**PCN# 20130128001
MSA ISO leadframe - CMS C1301064
Information Only**

Date: 1/31/2013
To: MOUSER PCN

PCN Number:	20130128001	PCN Date:	01/31/2012		
Title:	MSA ISO 1/2 etch leadframe - CMS C1301064				
Customer Contact:	PCN Manager	Phone:	+1(214) 480-6037		
Dept:	Quality Services				
Change Type:					
<input type="checkbox"/>	Assembly Site	<input type="checkbox"/>	Assembly Process	<input checked="" type="checkbox"/>	Assembly Materials
<input type="checkbox"/>	Design	<input type="checkbox"/>	Electrical Specification	<input type="checkbox"/>	Mechanical Specification
<input type="checkbox"/>	Test Site	<input type="checkbox"/>	Packing/Shipping/Labeling	<input type="checkbox"/>	Test Process
<input type="checkbox"/>	Wafer Bump Site	<input type="checkbox"/>	Wafer Bump Material	<input type="checkbox"/>	Wafer Bump Process
<input type="checkbox"/>	Wafer Fab Site	<input type="checkbox"/>	Wafer Fab Materials	<input type="checkbox"/>	Wafer Fab Process
PCN Details					
Description of Change:					
<p>Change MSA isolation devices to 1/2 etch pull out leadframe. Customers may notice the internal configuration changes particularly the lead tip geometries.</p> <p>Change from configuration A:</p>

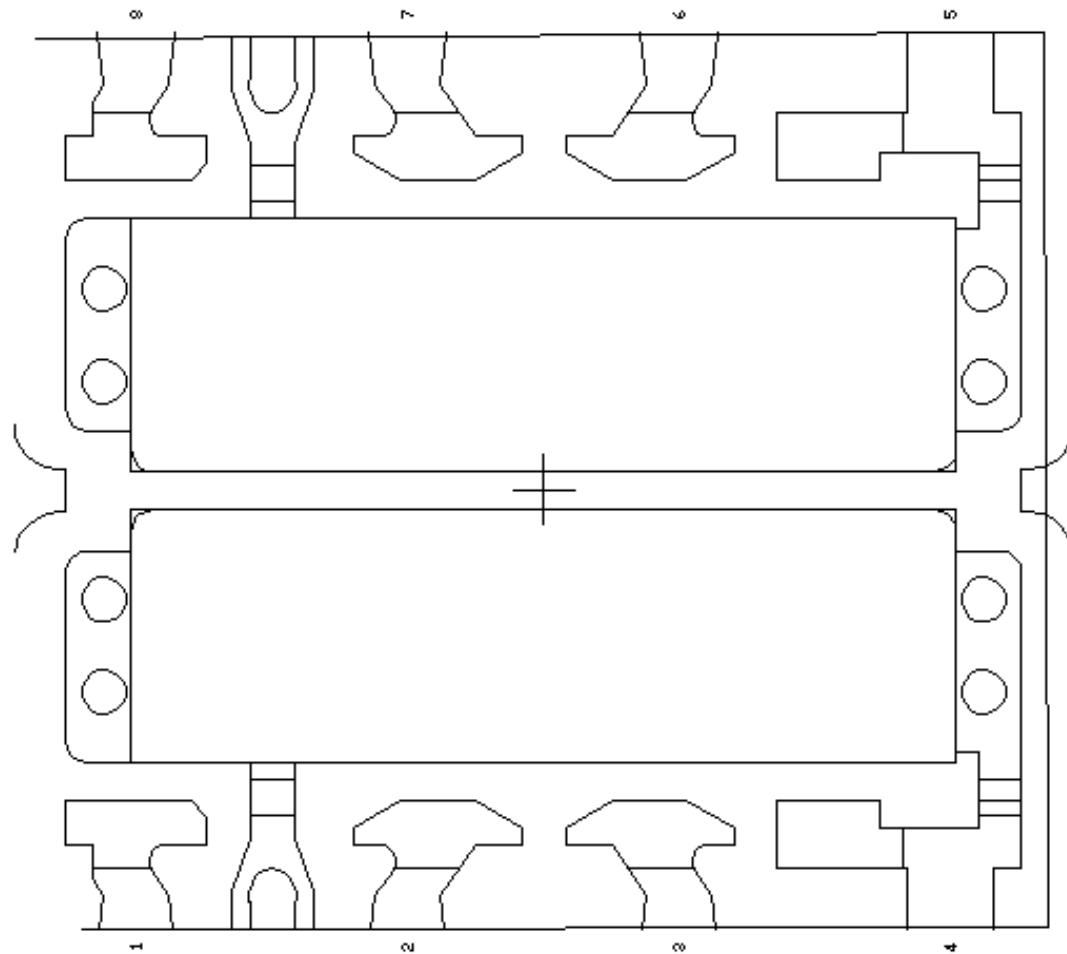
Change from configuration B:

Change to:

Improve margin of package creep and clearance dimensions.
